STUENKEL ROAD OVER I-57
TEMPORARY LIGHTING PLANS - STAGE 1&2
SCALE: AS NOTED SHEET NO. 12 OF 24 SHEETS STA. ----- TO STA. -----

F.A.I. RTE.	SECTION	COUNTY	TOTAL SHEETS	SHEET NO.
57	99-1HB-R	WILL	679	330E
CONTRACT NO. 60L69

ADDENDUM 1 1/03/14

E-7E

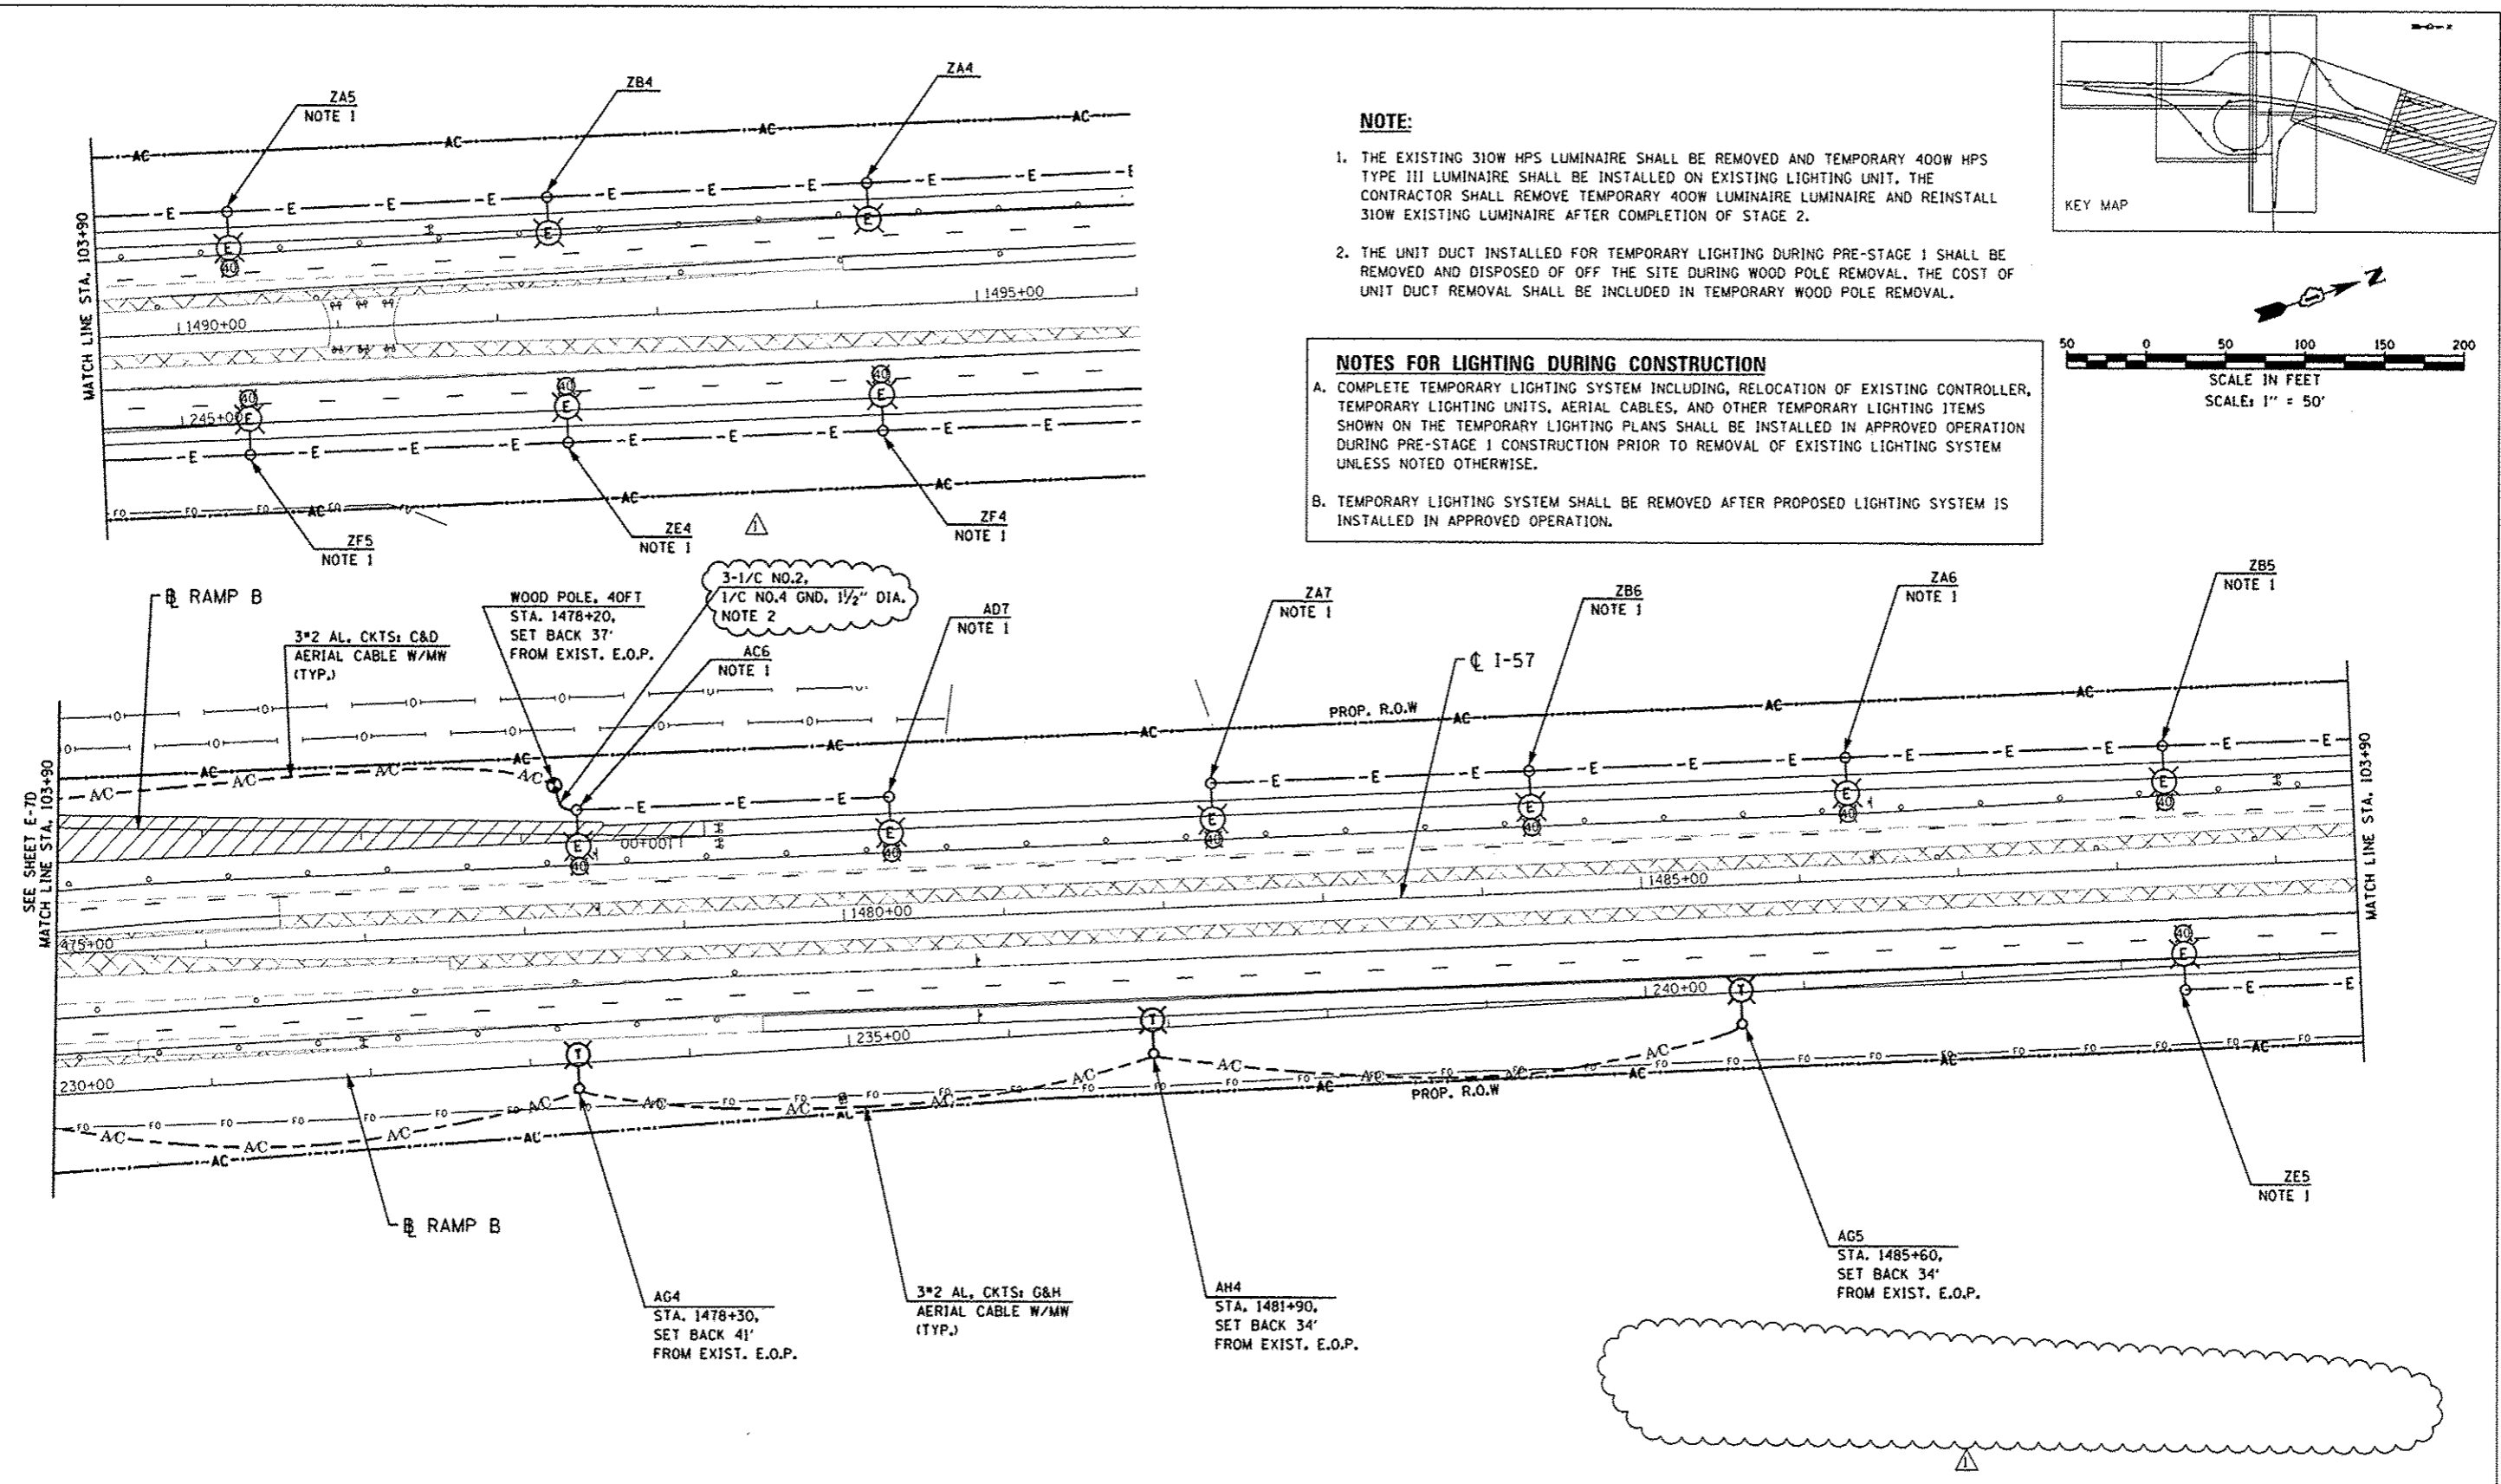
1. THE EXISTING 310W HPS LUMINAIRE SHALL BE REMOVED AND TEMPORARY 400W HPS TYPE III LUMINAIRE SHALL BE INSTALLED ON EXISTING LIGHTING UNIT. THE CONTRACTOR SHALL REMOVE TEMPORARY 400W LUMINAIRE AND REINSTALL 310W EXISTING LUMINAIRE AFTER COMPLETION OF STAGE 2.
2. THE UNIT DUCT INSTALLED FOR TEMPORARY LIGHTING DURING PRE-STAGE 1 SHALL BE REMOVED AND DISPOSED OF OFF THE SITE DURING WOOD POLE REMOVAL. THE COST OF UNIT DUCT REMOVAL SHALL BE INCLUDED IN TEMPORARY WOOD POLE REMOVAL.
